Full-Size Trains for the Interborough Express

Could full-size, modern R211 subway cars fit on the proposed Interborough Express (IBX) transit line? The answer could be YES. The MTA should try harder to make that happen.

MTA’s Walkway Clearance Envelope

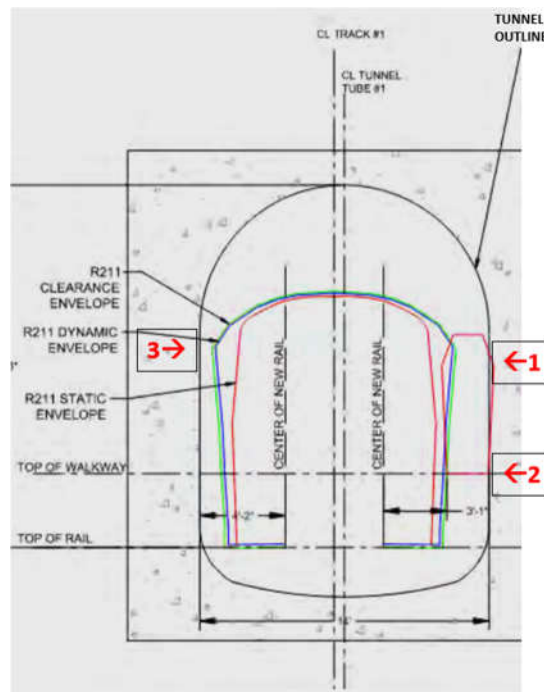
The fire safety rules (NFPA 130) for tunnels not only require a 24-inch wide walkway at the train floor level, but also require a 30-inch wide clearance between a stationary (static) train and the tunnel wall at 62-inches above the walkway, and a 17-inch wide clearance at 80-inches above the walkway.⁶ A non-binding annex to those rules⁷ suggests the symmetric clearance envelope at the left below⁸ and that is the envelope used in the MTA’s IBX studies. But the rule itself does not require that particular clearance envelope. It appears that the envelope at the right below also would satisfy the rule.

Suggested Walkway Clearance Envelope
